Preview: Supporting Material – TQM Related Comments (259, 260) for 800GBASE-LR1, 800GBASE-ER1-20, 800GBASE-ER1

**IEEE P802.3dj Task Force
Optical / Logic Ad hoc Meeting
29 August 2024**

Introduction

Calibrated Coherent Detector Front-End

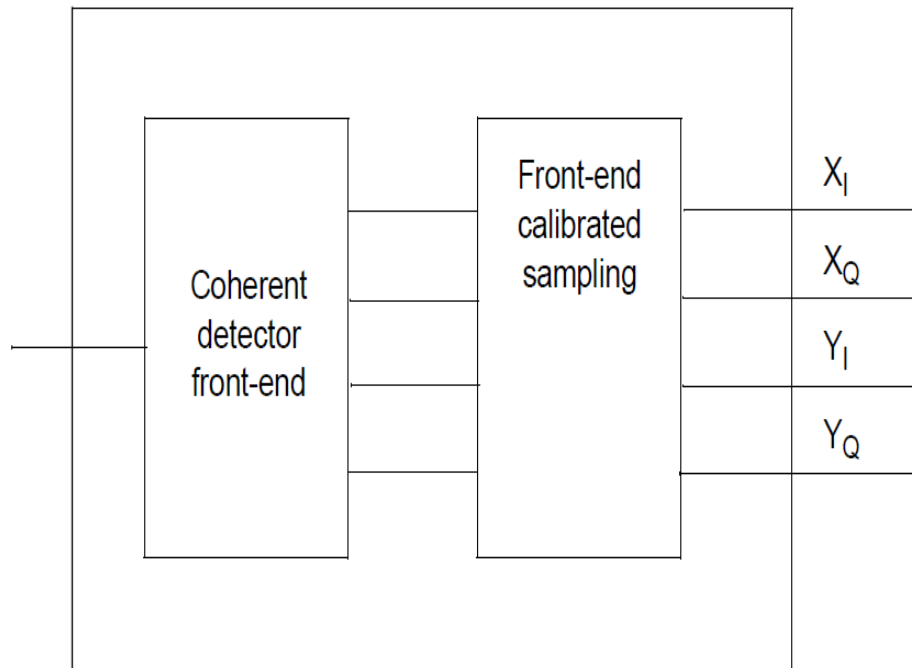
- Add proposed table consisting of parameter values for post calibration residuals

Description	Value	Unit
X-Y gain error (max)	0.2	dB
X-Y skew (max)	0.5	ps
I-Q phase error for X (max)	2	degree
I-Q gain error for X (max)	0.2	dB
I-Q skew for X (max)	0.2	ps
I-Q DC offset for X (max)	-26	dB
I-Q instantaneous offset for X (max)	-20	dB
I-Q phase error for Y (max)	2	degree
I-Q gain error for Y (max)	0.2	dB
I-Q skew for Y (max)	0.2	ps
I-Q DC offset for Y (max)	-26	dB
I-Q instantaneous offset for Y (max)	-20	dB
Bandwidth mismatch [X,Y:I,Q] (max)	1	GHz
Carrier frequency offset (max)	0.1	GHz

- Add subclauses providing definitions of noted parameters

Coherent Detector Front-end

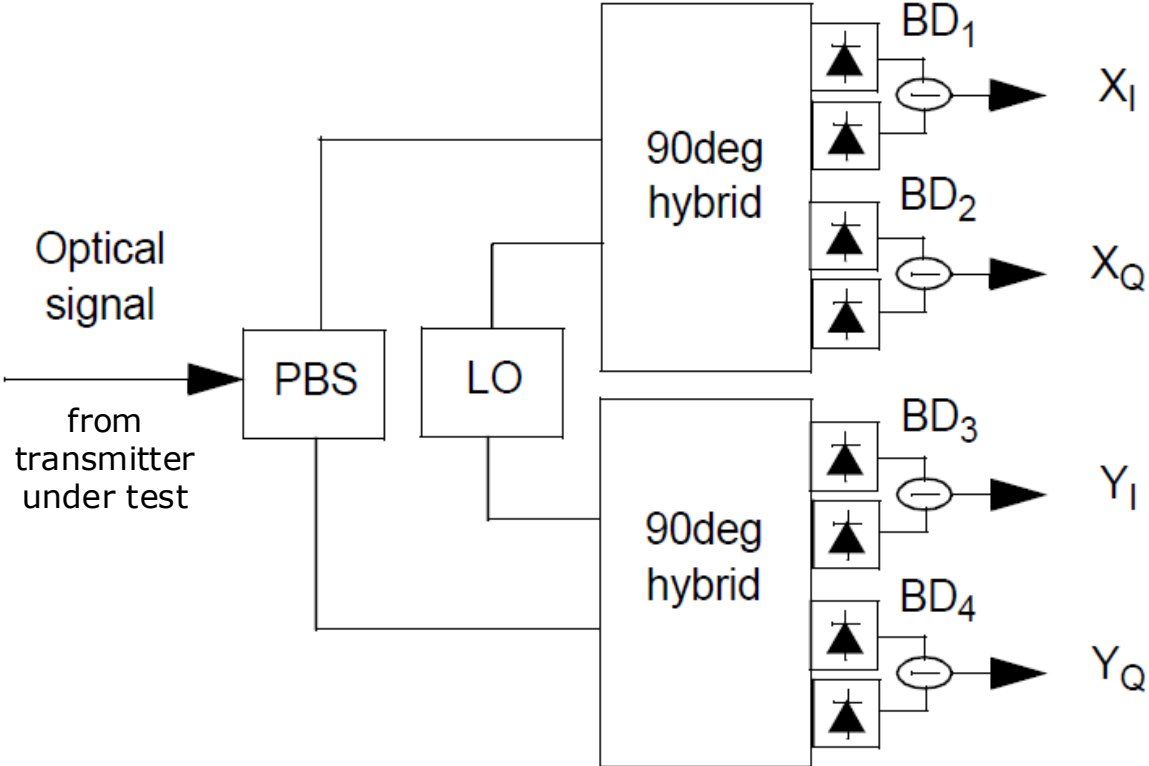
Add text:

The incoming optical signal is split into two orthogonal polarizations (x and y) by a polarization beam splitter (PBS). The two polarization components are mixed with their co-polarized components from the optical local oscillator (LO) in two 90-degree optical hybrids, followed by four balanced photo-detectors (BD_x), which convert the four components of the optical signals into their corresponding electric signals.

Add Table: Coherent detector front-end parameters

Description	Value	Unit
3-dB bandwidth (min)	65	GHz
ENOB	5	bit
Oversampling ratio	1.25	
Local oscillator linewidth (max)	30	kHz

Add subclauses providing definitions of noted parameters

Offline digital signal processing used for TQM calculation

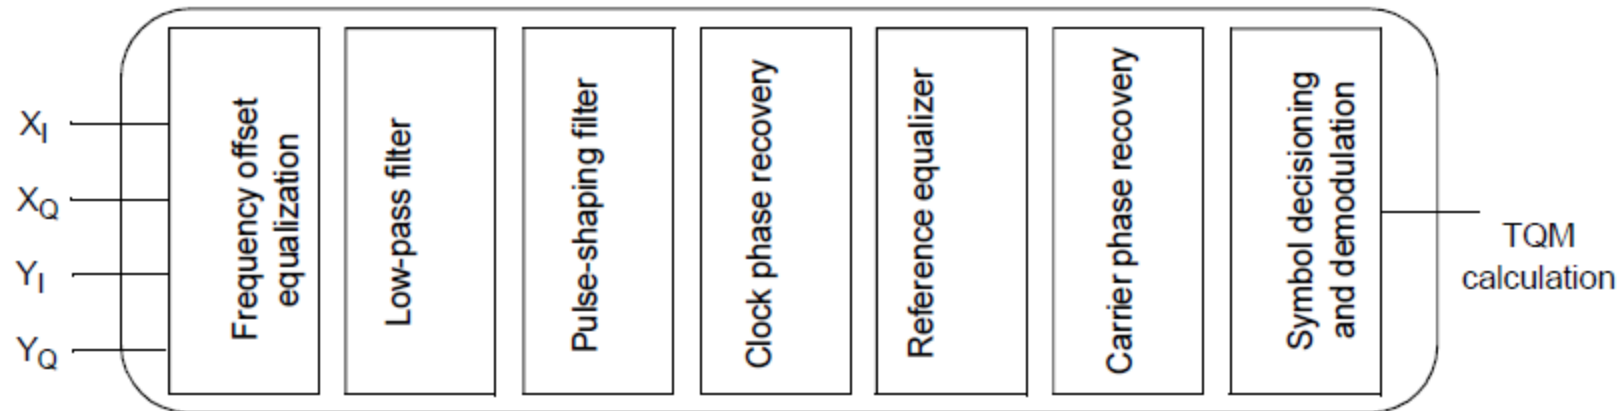
- Add subclauses providing definitions of noted steps. Leverage descriptions for each step on Page 7 of fan_3dj_02a_2407.pdf.
